Part Number Update

Bulletin No: PNU-247

subject: New Bendix® TABS-6™ Advanced Multi-Channel Modules - UPDATED

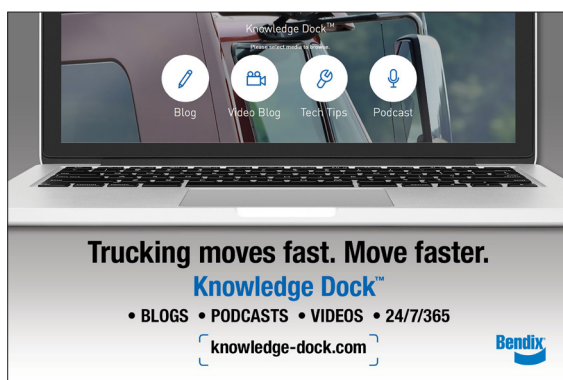
1. Replaces the obsolete OE part number. The AM part includes 2 or 4 speed sensor cables (part number K141692) based on the Electronic Control Unit (ECU) configuration. If the ECU was equipped with a TABS-6 Advanced MC pigtail with the diagnostic, Aux I/O, or Sensor 1 being used, a new pigtail cable must be installed. Refer to the table on the back of this document to find the proper replacement part number.
2. Replaces the new OE part number. No wheel speed sensor adapter cables or new pigtail cable are required.

When replacing any older Bendix® TABS-6™ Advanced Multi-Channel Module with the new design, the diagnostic, auxiliary, and sensor cables (12-pin connector cable) used with the system must also be replaced. The previous cables **are not compatible** with the new TABS-6 Advanced Module. The old 12-pin cable **must not** be used. Below are the old cable part numbers shown alongside the new replacement cable part numbers required when replacing the Module.
